# FINAL PLAT LOT 1, BLOCK 1 CROSSINGS ADDITION

SITE PLAN REVIEW

## RACETRAC SITE PLAN - SH 205 NORTH OF IH-30 AND LAKESIDE CHEVROLET

**Agenda Item:** P&Z 91-1-CUP/SP/FP - Hold Public Hearing and Consider Recommending Approval of a Request From Racetrac, Inc., for a Conditional use Permit for a Building Not Meeting Materials Requirements and Approval of a Site Plan and Final Plat for a Self Serve Gas Station Located on SH-205 North of I-30

## SITE PLAN

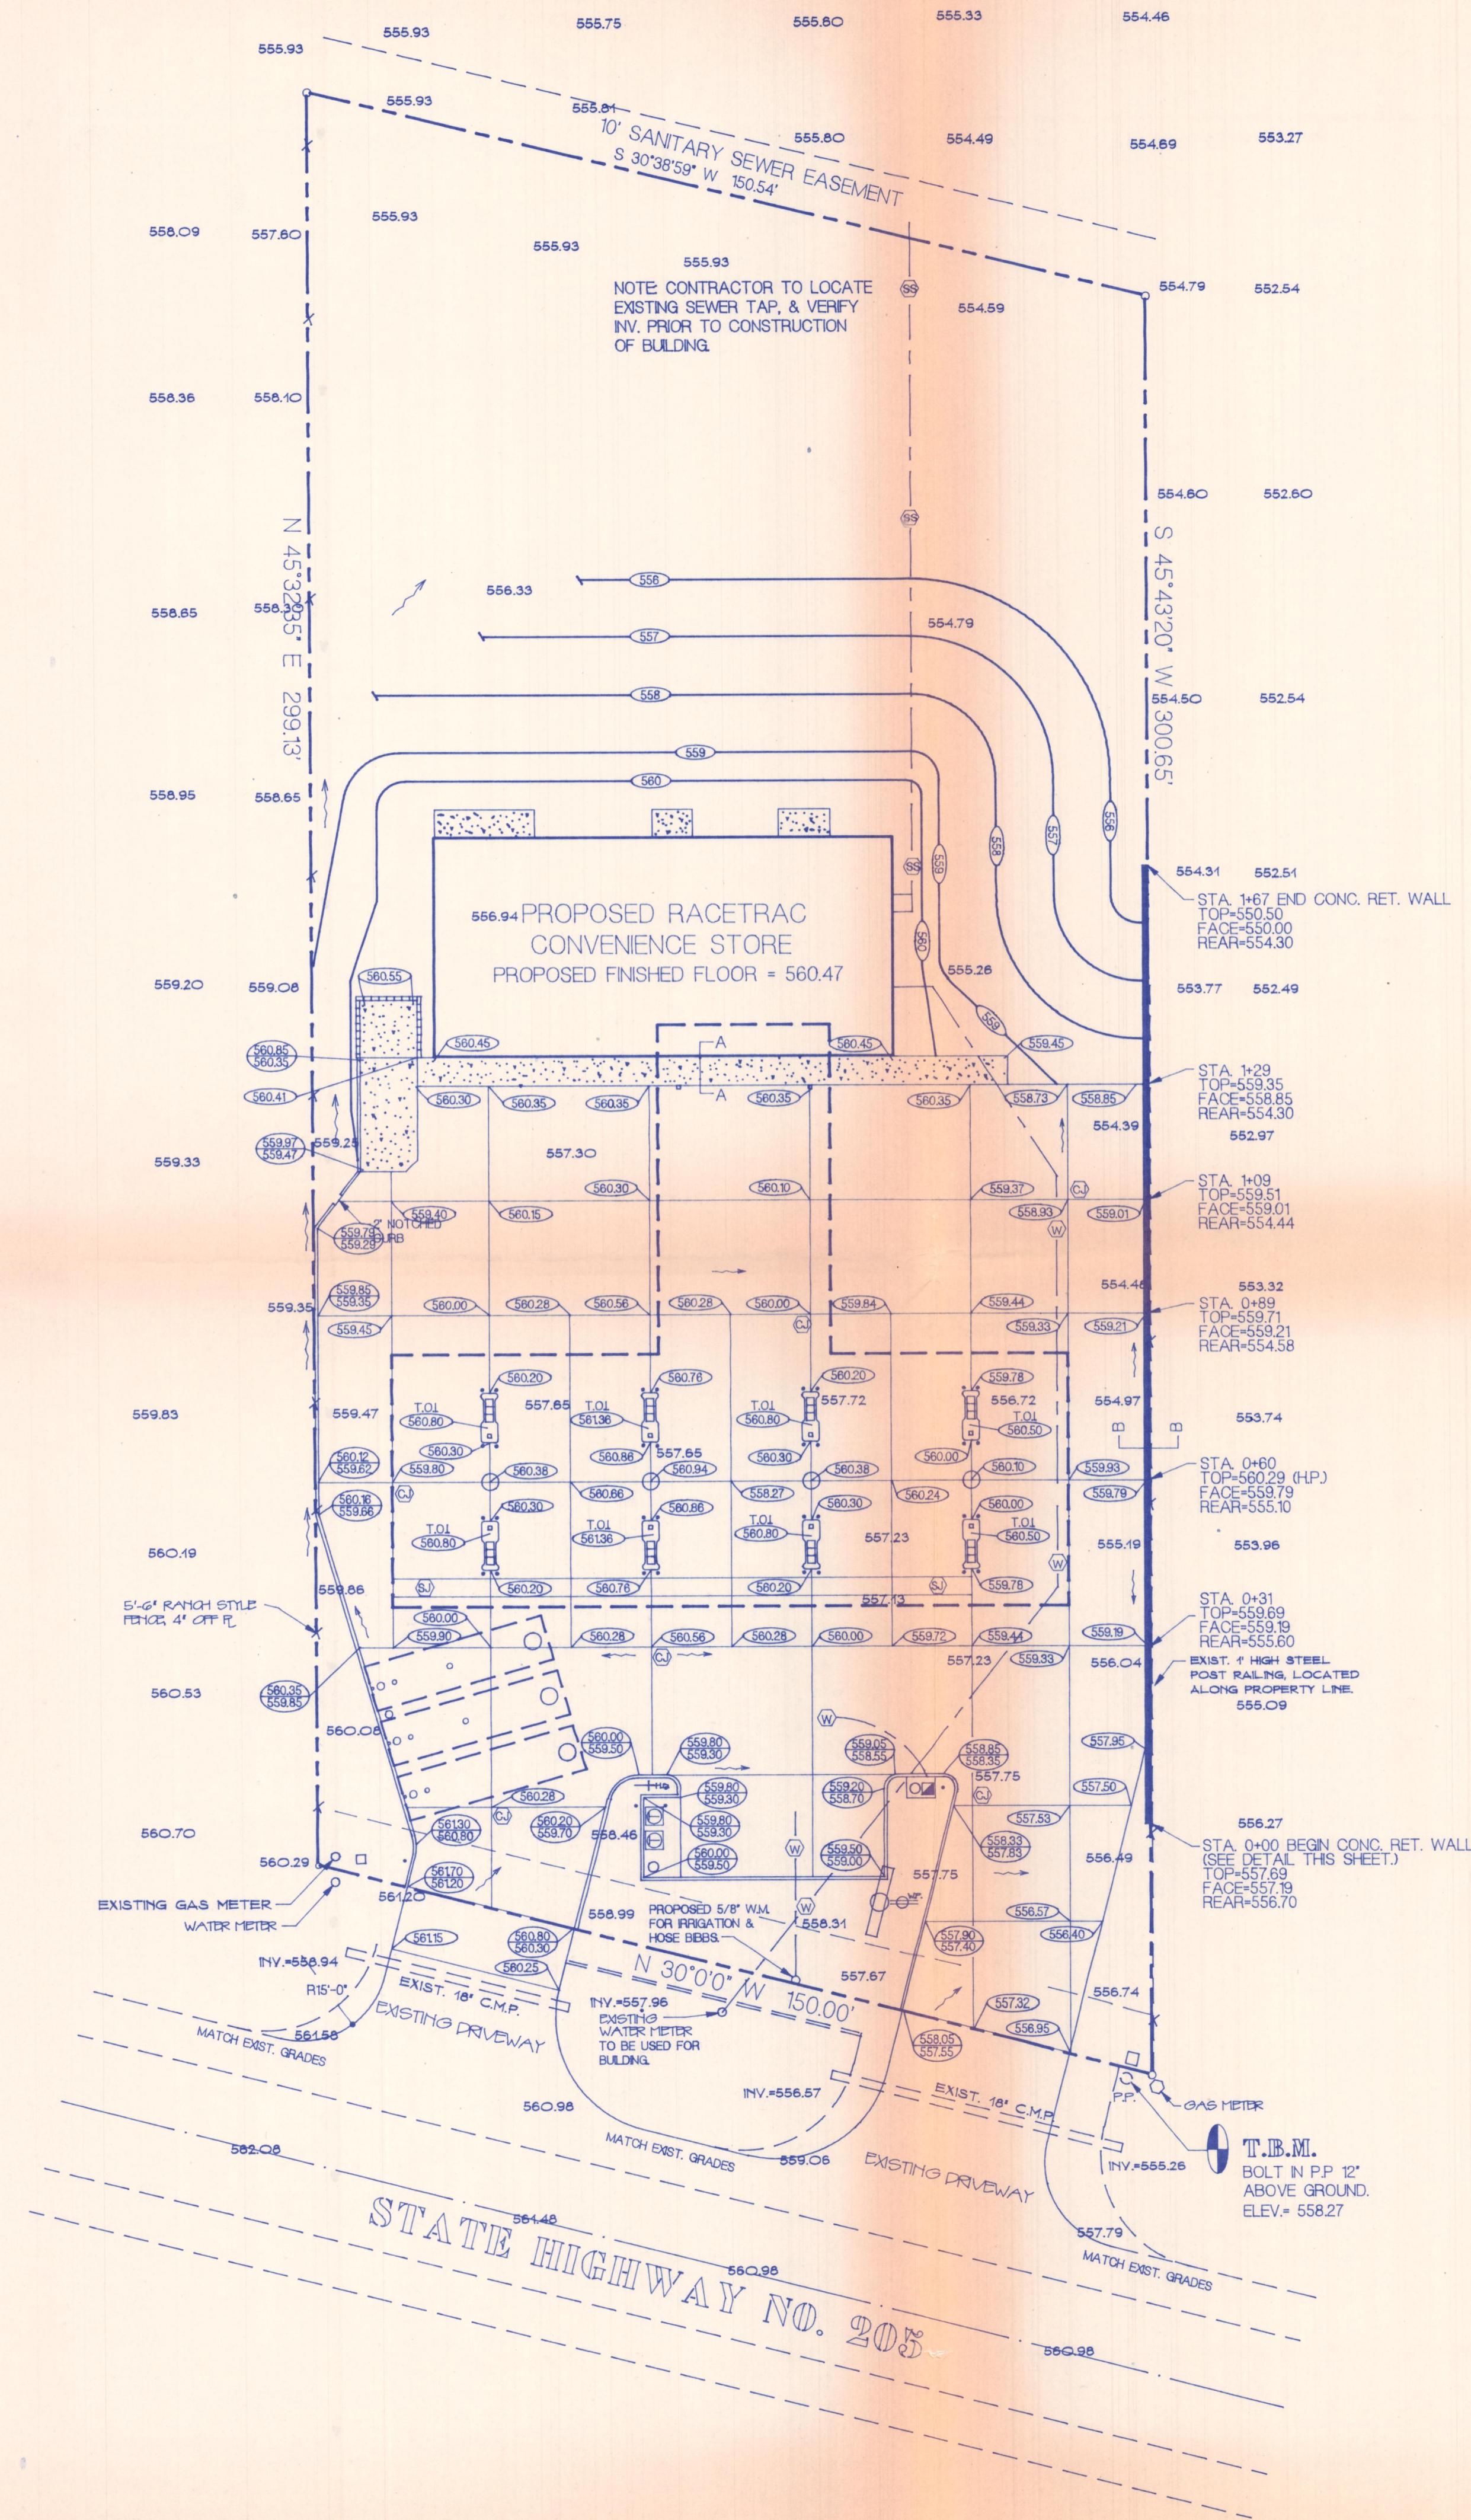
d. <sup>row</sup> area in front of the prop needs to be grassed -  
show on plans.

13. Reduction of openings or reduce to one - need to show proximity of adjacent drives
14. Buddy square footage & dimensions?
15. 16 parking spaces - where are the 15 spaces
16. Elevation + color of signage + canopy
17. Nearest fire hydrant location
18. Possible ROW dedication

3. The radii at each proposed driveway encroach upon the neighboring properties to the north and south. In order to correct this, three things could be done - reduce the driveway widths from 30 to around 24 FT, move the driveways inboard to the property thereby reducing the 68 FT clear space between driveways, and reduce the size of the radii. A small reduction of each of these factors would eliminate the encroachment problems without unduly sacrificing the site plan.

4. The site plan shown includes two driveways. City standards identify driveways for a site to be generally separated by distances of 150 FT. The plan shown, however, is a good one, and the site may have access in the future to a median opening at the north property line. The plan as presented seems best.

1. Require applicant to show joint access easement to the property east of this site.
2. Require applicant to show an access easement across the property, north-south, for the future potential use of the adjoining properties.
3. Eliminate the encroachment of the applicant's curb return radii onto adjoining properties.

The Commission recommended approval of the site plan with the conditions that a parapet wall be constructed along the back of the building to match the other walls, and that the canopy supports and the sign pole be wrapped with the split face block to match the material used on the main structure.

There was considerable discussion regarding the request to continue to have two drives rather than one drive. We had asked Mr. Reglin to review the plan and he indicated that either one or two drives could work but that two drives seemed to better serve the layout proposed by the applicant. The Commission approved the site plan with the two entrances.

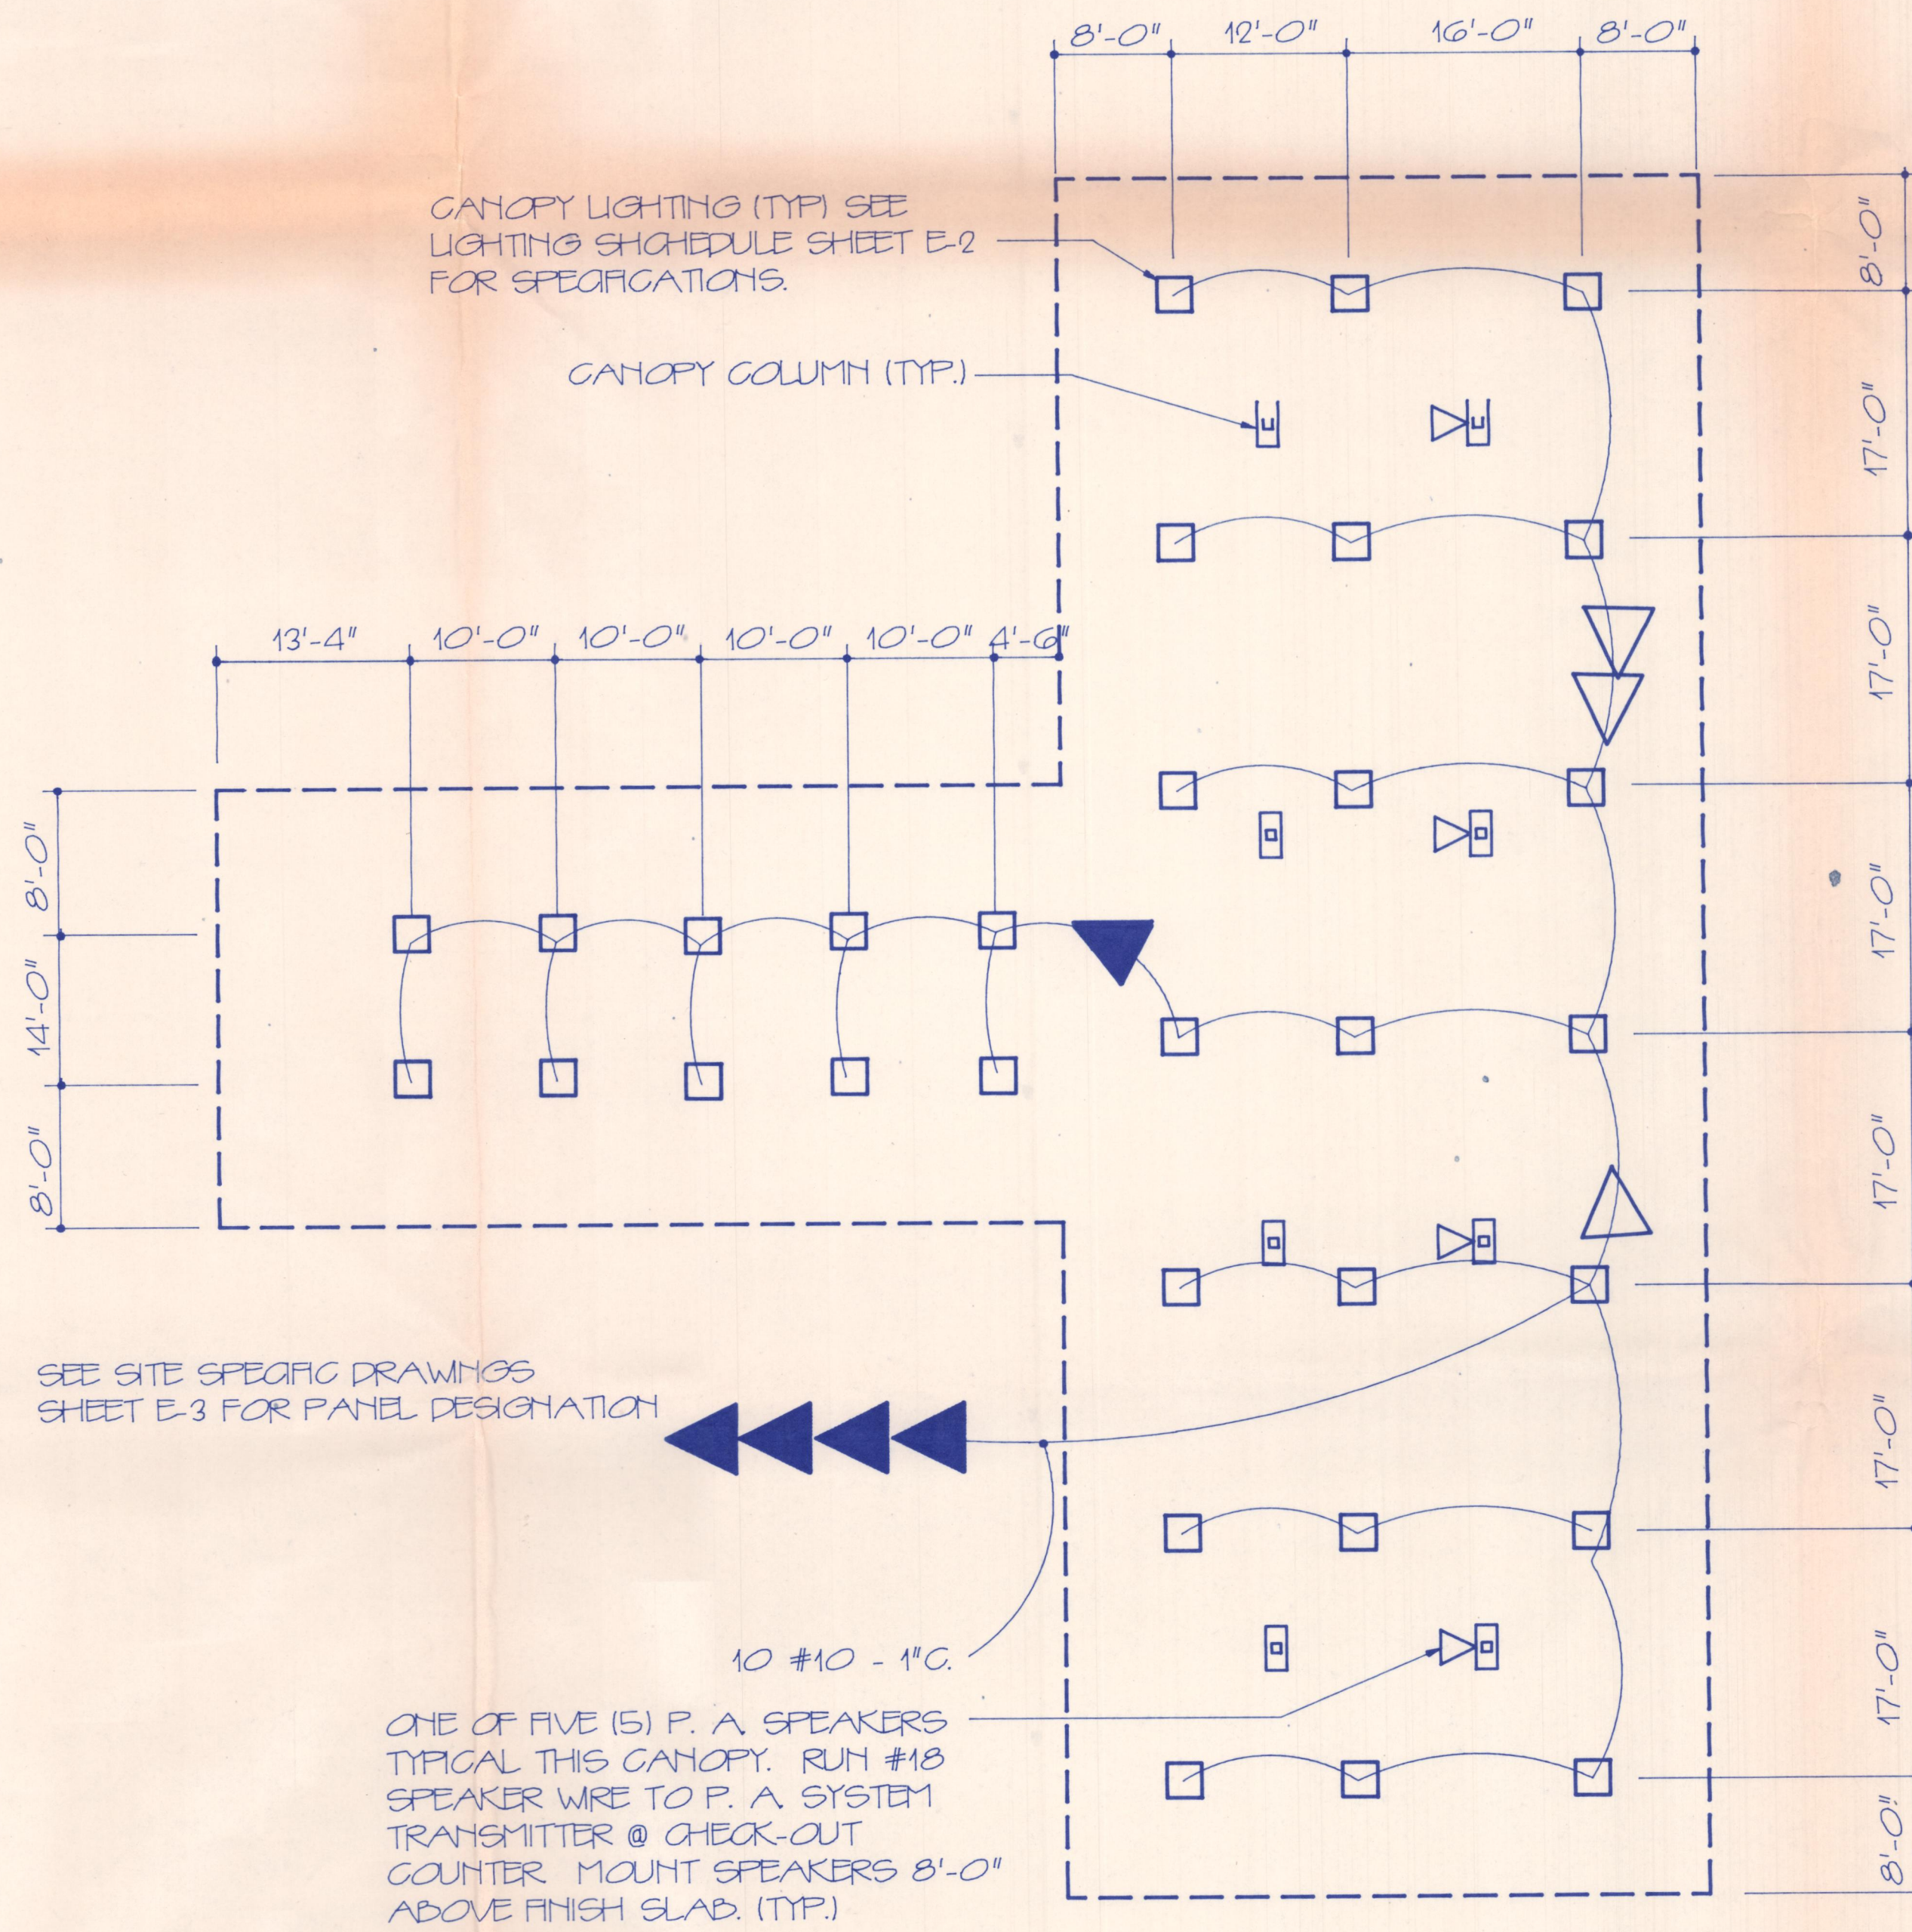
~~Do you~~ a  
need to grass/irrigate spray to ROW  
and returns

drives OK but could function  
w/ wheel 1 drive -  
would not have access to  
median opening
